AMENDMENT 7

Tabulation of Revisions

<u>FSAR Section</u>	<u>Reason for Revision</u>
2.1	Update of population distribution tables.
2.2	Deletion of requirement for H <sub>2</sub> S detectors.
2.4 & 2.5	Update of groundwater and geology sections.
8.2	Switchyard design change to ring bus and transmission line name change.
8.3	Specify method of instrument cable installation in raceways.
9.2	Update essential chilled water system FEMA.
10.4	Update AFW system FEMA.

NRC DOCKET NUMBERS 50-424 AND 50-425  
CONSTRUCTION PERMIT NUMBERS CPPR-108 AND CPPR-109  
VOGTLE ELECTRIC GENERATING PLANT - UNITS 1 AND 2  
FSAR AMENDMENT NUMBER 7

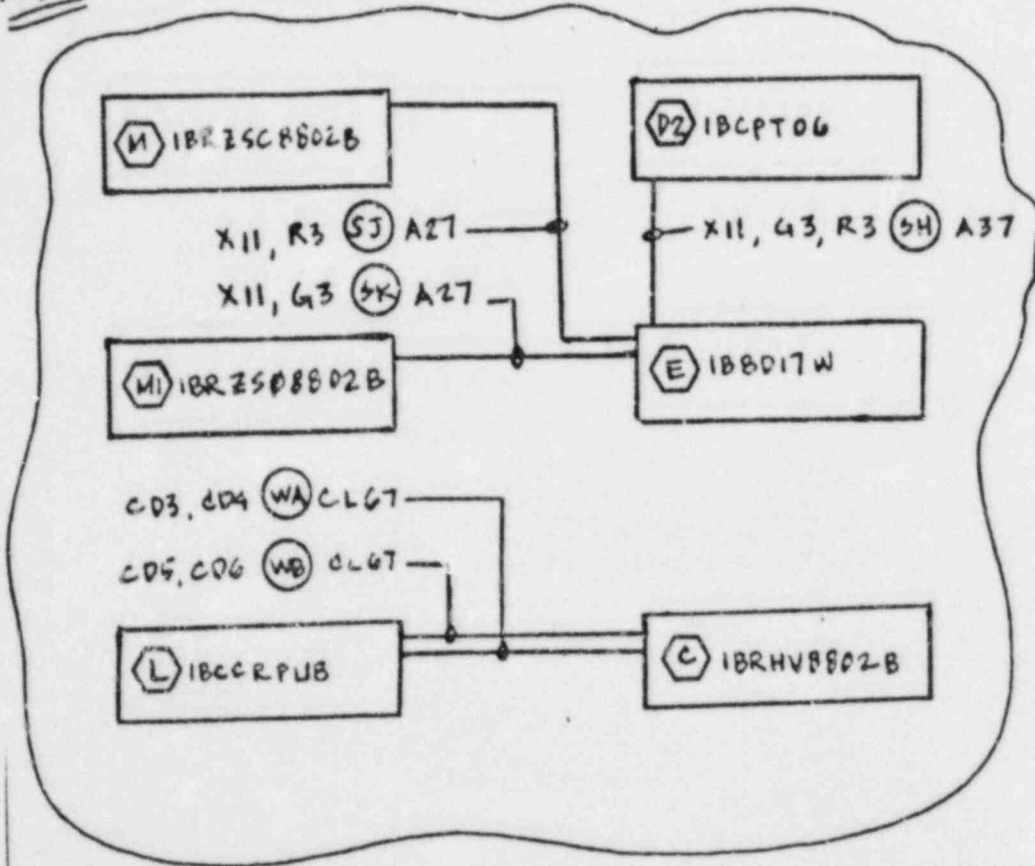
DESCRIPTION OF CHANGE

ADD

- ⬡ M = FHB LVL A
- ⬡ M1 = FHB LVL A
- ⬡ L = CB LVL 2
- ⬡ D2 = CB LVL 2
- ⬡ E = AB LVL B
- ⬡ C = FHB LVL A

ELEMENTARY DIAGRAM  
SAFETY INJECTION SYSTEM  
IHV-8809A

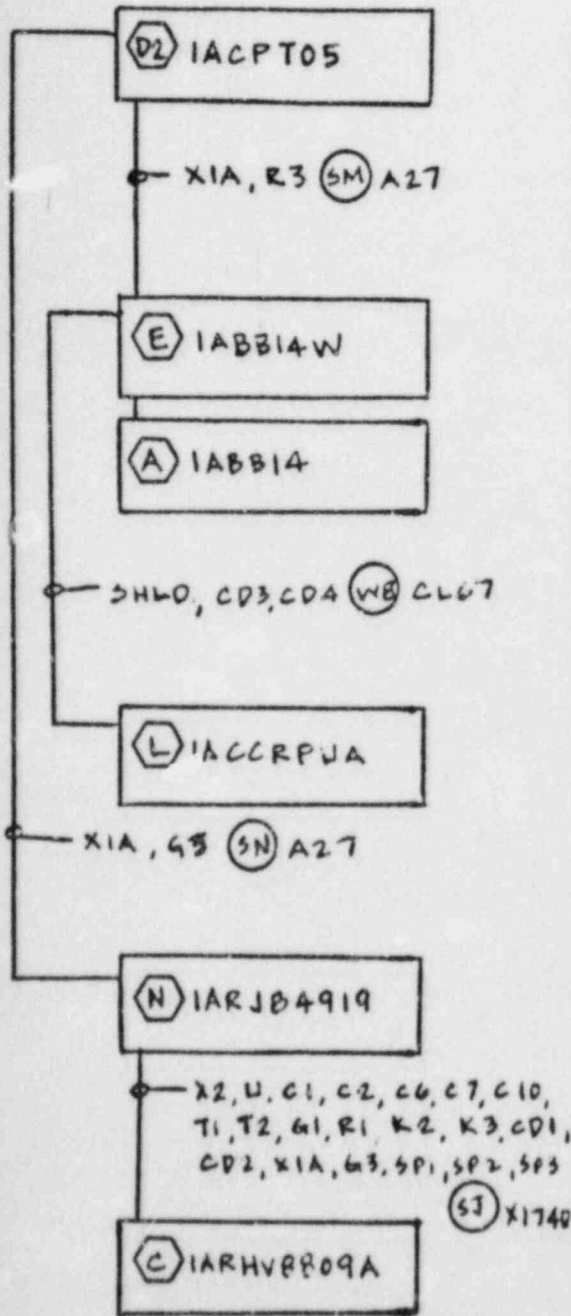
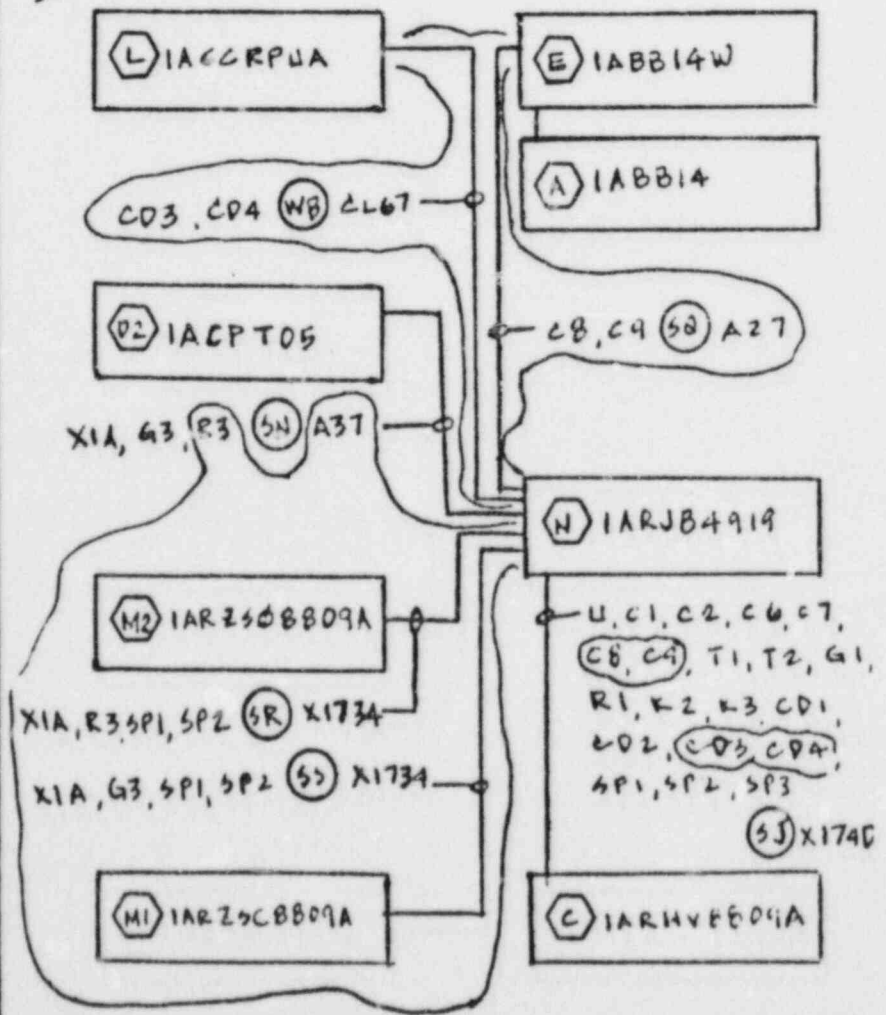
DESCRIPTION OF CHANGE

- (L) = CB LVL A
- (D2) = CB LVL A
- (M2) = AB LVL A
- (MI) = AB LVL A
- (E) = AB LVL 1
- (A) = AB LVL 1
- (N) = AB LVL A
- (C) = AB LVL A

IS

ELEMENTARY DIAGRAM  
SAFETY INJECTION SYSTEM  
1HV-8809B

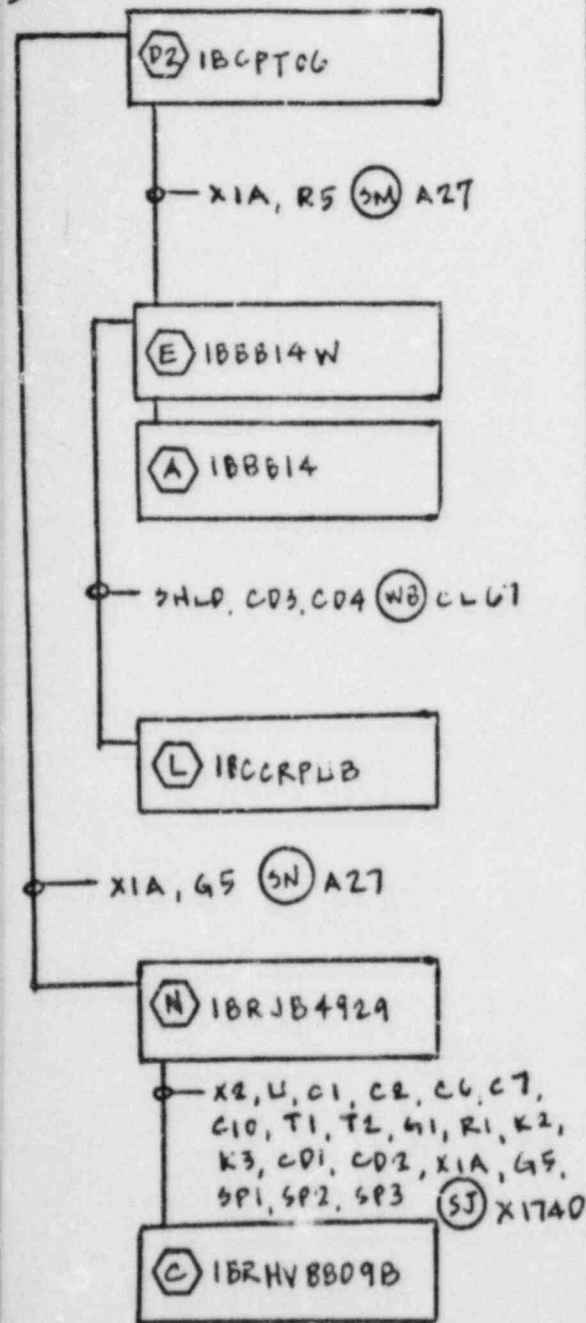
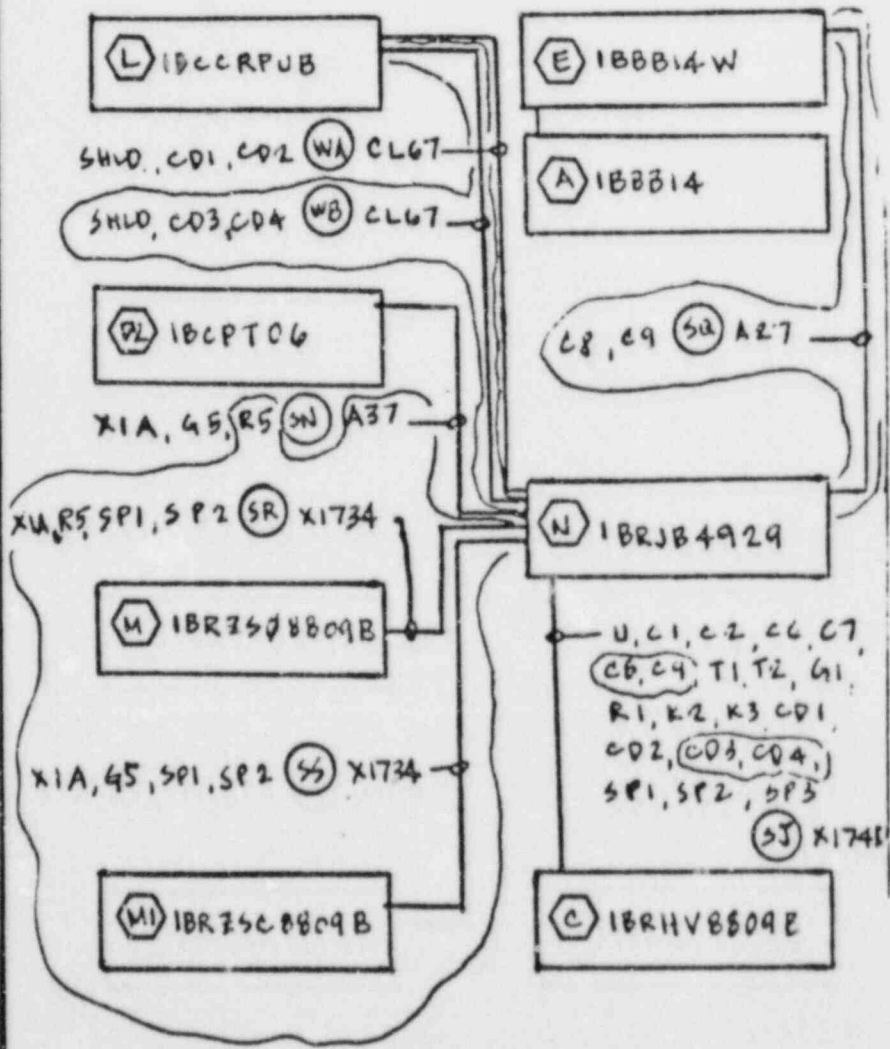
DESCRIPTION OF CHANGE

- ⬡ = CB LVL 2
- ⬡ = AB LVL 1
- ⬡ = CB LVL 2
- ⬡ = AB LVL 1
- ⬡ = FHB LVL A
- ⬡ = FHB LVL A
- ⬡ = FHB LVL A
- ⬡ = FHB LVL A

IS
